**Flood Control Project Maintenance  
Levee Inspections**

**Fall 2012 Levee Maintenance Deficiency Summary Report**

**Levee District No. 0002 (Glenn County)**

Waterway		Bank	Unit Miles
Unit No. 01 Glenn County Sacramento River		Right	4.89

USACE 2012 Photo #2

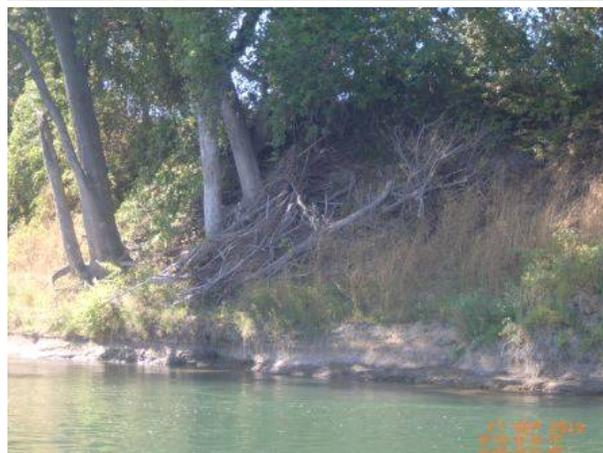
Levee Mile Report Line	4
Start Levee Mile	0.08
End Levee Mile	0.08
Location	Water Side
Category	Supplemental
Item	USACE Erosion Survey
